Observation to An Coimisiún Pleanála on application

PAX07.323699 proposed wind farm at the townlands of BEAGH, BEAGHMORE, CLOONBAR, CLOONMWEELAUN, CLOONAGHLASHA, CLOONTEEN, CORITLAUN, DERRYMORE, IRONPOOL, SHANCLOON, TOBEROE, TONACOOLEEN, CO GALWAY.

To erect 11 turbines with a tip height of up to 179 metres

**PEER REVIEW OF APPROPRIATE ASSESSMENT SCREENING AND NATURA
IMPACT ASSESSMENT WITH REGARD TO APPLICATION FOR PLANNING
PERMISSION BY RWE RENEWABLES LTD FOR "SHANCLOON
WINDFARM" (PAX07.323699)**

Fig. 1 : The development site with principal drainage (from EIAR Appendix 12.3:Flood risk assessment)

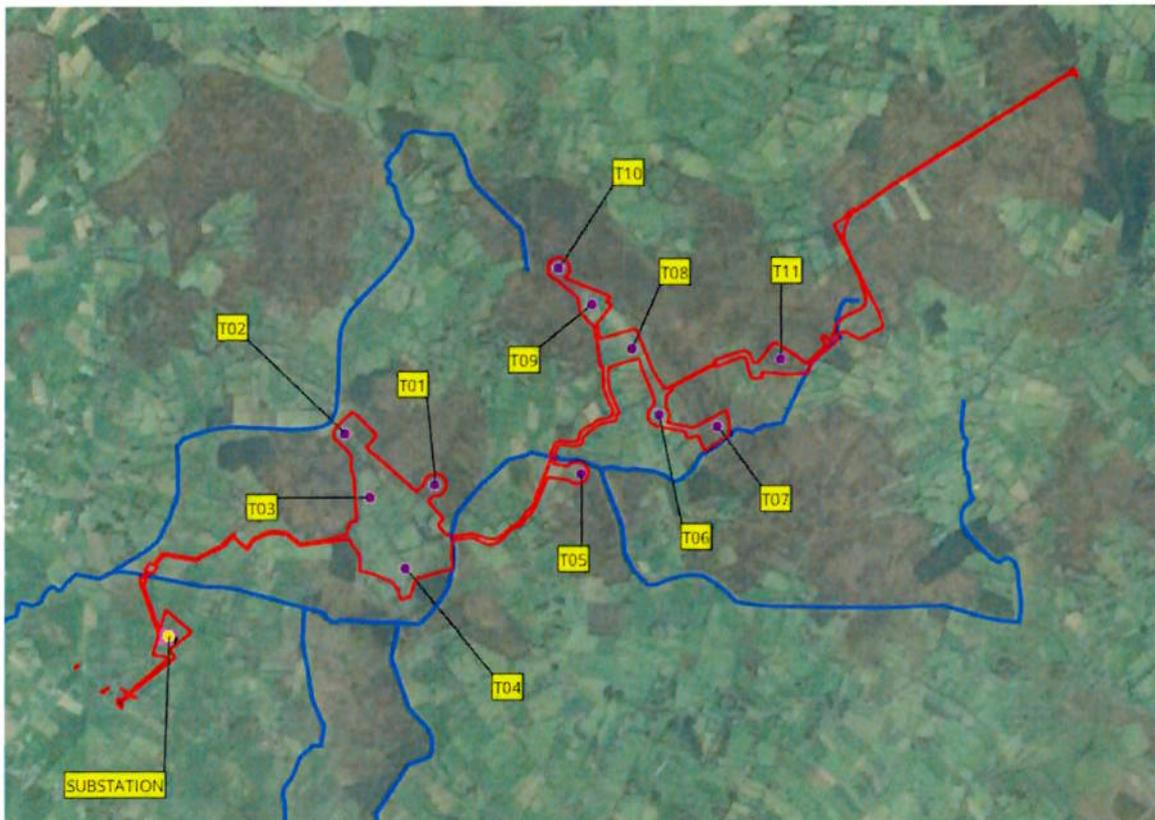
There are many contradictory statements in the reporting of the geology and hydrogeology particularly in respect of the permeability of the various geological strata on site, suggesting the hydrological regime is not well understood.

Plate 1 Proposed Shancloon Wind Farm's Substation Location (13th November 2025)

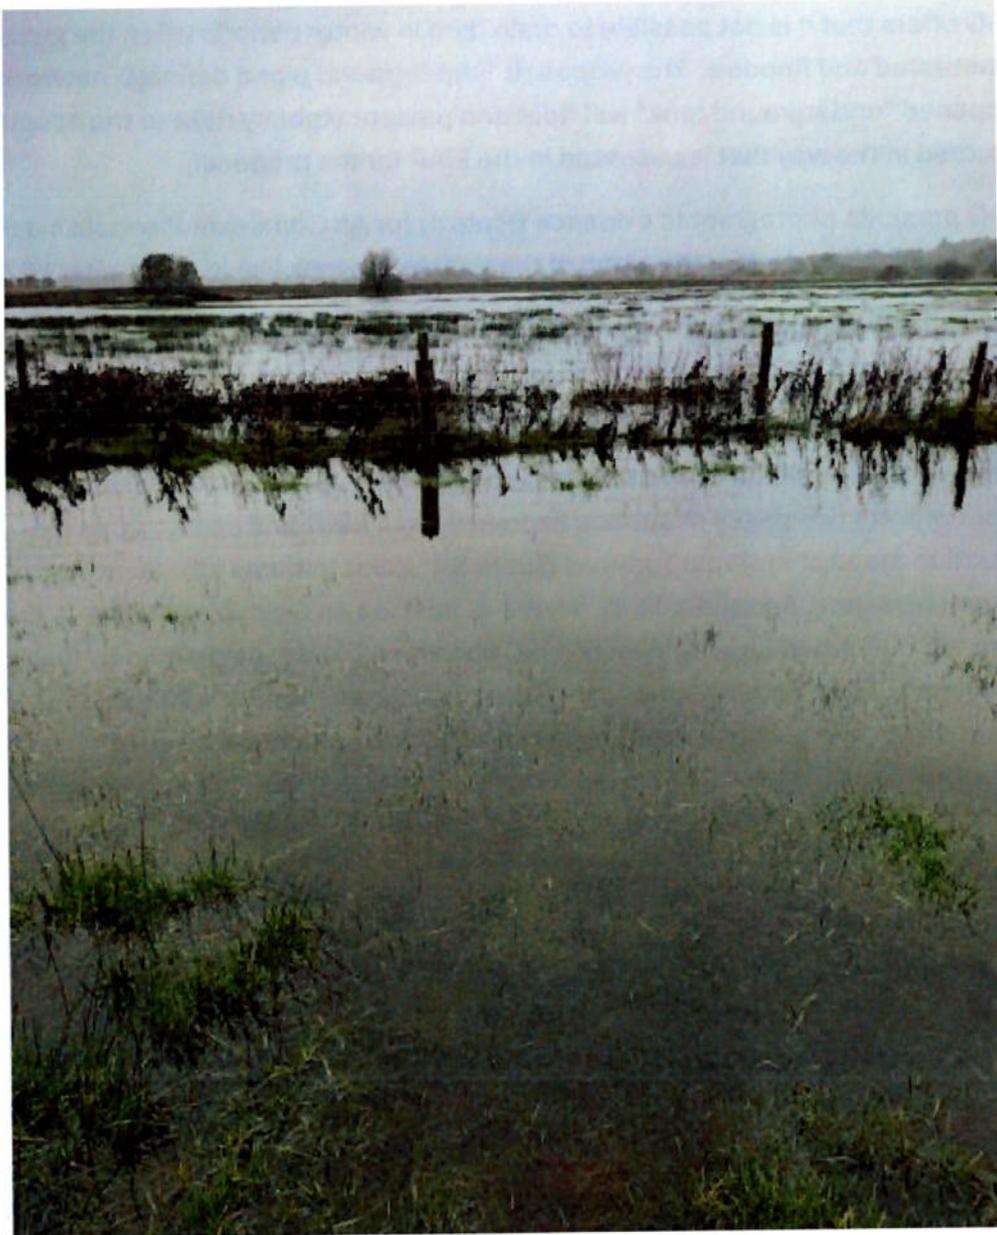
An Coimisiún Pleanála is asked to provide justification for substation and Wind Turbine locations in flooded plains of bog land in a conduit karst groundwater system where the applicant reports two pages of surface expressions of karst and some within the construction areas of multiple Turbines (Table 3-1: Karst features identified during the Site reconnaissance, Appendix 11.2). Hydro-G advises An Coimisiún Pleanála that the risks are too high when placing ‘Exceptional Abnormal Loads’, as defined by the Road Traffic (Construction Equipment & Use of Vehicles) Regulations of 2003, on peat and gravel substrate over a landscape littered with Dolines connecting to a subterranean karst conduit aquifer. It is true that the tonnage associated with the Substation and the Cranes and hoists lifting the masts, hubs and blades will exceed 180 tonnes.

The Flood Risk Assessment has underestimated the frequency of flood events. Examination of Geological Survey of Ireland Seasonal Flood Maps, historic OS maps, newspaper reports and local information reveals that there have been far more flood events in recent years and in history than the Flood Risk Assessment admits. The area is therefore significantly more flood prone than the Flood Risk Assessment for the proposed development has portrayed it to be. The refusal to consider groundwater flood risk is an inappropriate assessment strategy.

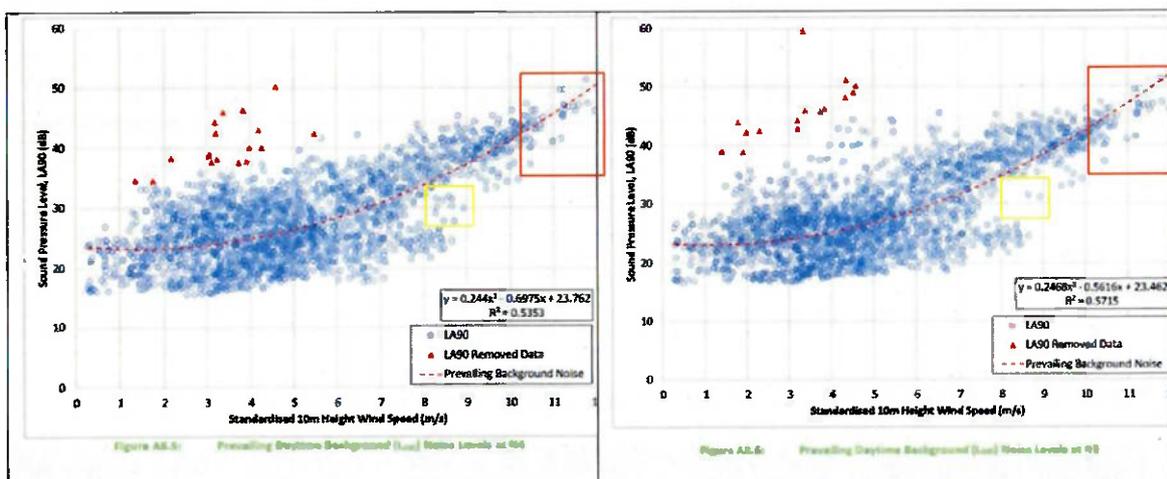
This concern relates to the integrity of the baseline measurements. Microphones were positioned in close proximity of trees and dense foliage, a siting approach known to inflate LA90 background noise due to wind induced rustle. This practice is inconsistent with the Institute of Acoustics Good Practice Guidance, including Supplementary Guidance Note 2 (SGN 2, Section 2.5.2), which advises against placing microphones close to vegetation for precisely this reason, as it can artificially elevate background levels and lead to less stringent operational noise limits.

Appendix 8, Table 8.1.7 shows a steep and consistent rise in night-time LA90 levels above approximately 6–7 m/s wind speed across multiple monitoring locations, strongly aligning with the expected effect of microphone placement near foliage. The magnitude of increase is extreme in some cases. For example, N8 nighttime levels rise by approximately 35 dB between 2 m/s and 12 m/s, a pattern characteristic of wind-induced contamination rather than genuine ambient noise conditions.

3. Unrealistic Similarities in Scatter Plots

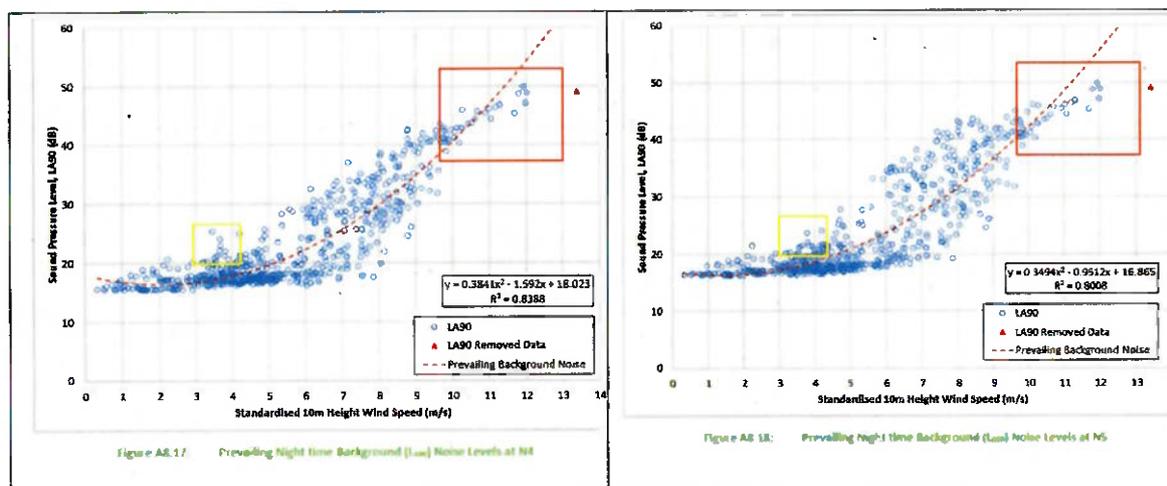
The background noise scatter plots for locations N4 and N5 are strikingly similar across all wind speeds, with the effect most pronounced above 10 m/s but evident throughout the full range. Although these monitoring locations are 1.5 km apart and were measured using four separate Class 1 sound level meters of three different models, conditions that would normally produce noticeable variation due to differing microphone wind responses, vegetation influence and local acoustic environments, the two datasets track each other with an unusually consistent offset of approximately 0–1.8 dB. They are not perfectly identical, so this is not a simple copy & paste error, rather it points to a more fundamental issue in how the background data has been generated or processed. This level of uniformity across two independent sites, at all wind speeds and during both day and night, is not representative of the natural variability seen in genuine field measurements and seriously undermines the reliability of the background noise assessment presented in the EIAR.

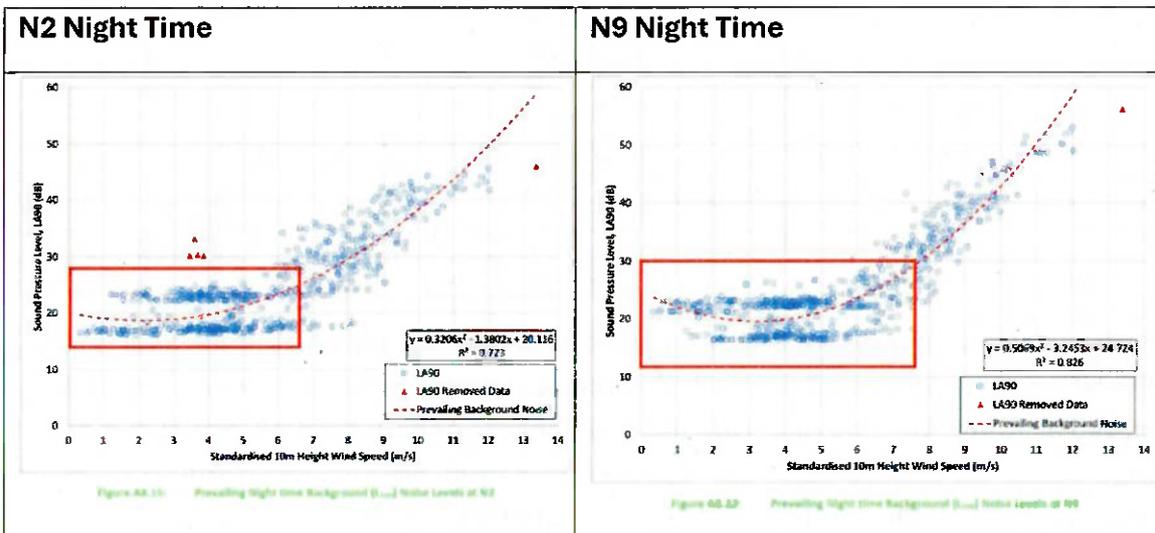
Further analysis shows that N11 is reported as having 739 valid night-time data points. The N11 monitoring period (Lot 1: 7–21 December 2022) covered 14 nights, with data logged at 10-minute intervals. With the dawn chorus period removed, this allows for a maximum of 30 valid samples per night, or 420 in total. Even if dawn chorus exclusions were not applied, the theoretical maximum would still be lower than the 739 valid samples reported. This discrepancy indicates that the dataset cannot reflect the actual measurement period and raises significant concerns regarding data handling and validation. It further undermines confidence in the integrity of the baseline and is inconsistent with the IOA Good Practice Guide requirements for transparent and accurate data reporting.

Location N2	Comment
	<p>Noise monitor located near tall trees.</p>

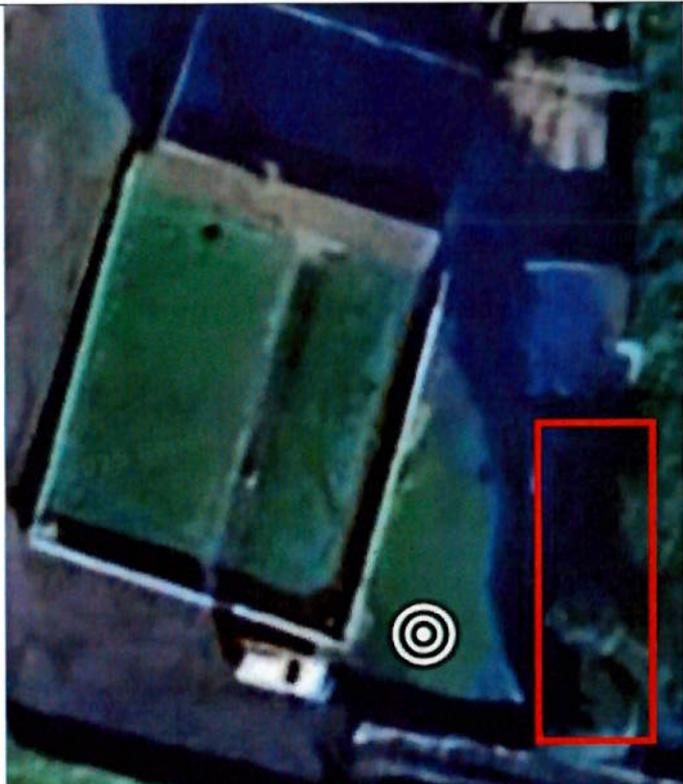
Location N3	Comment
	<p>Noise monitor near line of tall trees.</p>

Location N4	Comment
 An aerial photograph showing a residential area with a noise monitor icon (a bullseye) on a grassy field. Two red rectangular boxes highlight areas of dense trees near the noise monitor. The image is rotated 90 degrees clockwise.	Trees near noise monitor.

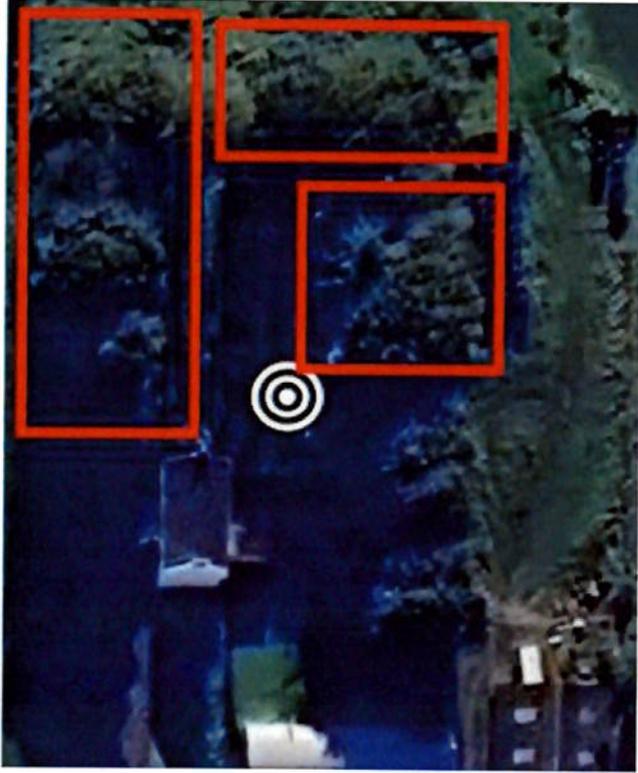
Location N5	Comment
	<p>Noise monitor fitted 7m away from 20m high evergreen trees.</p>
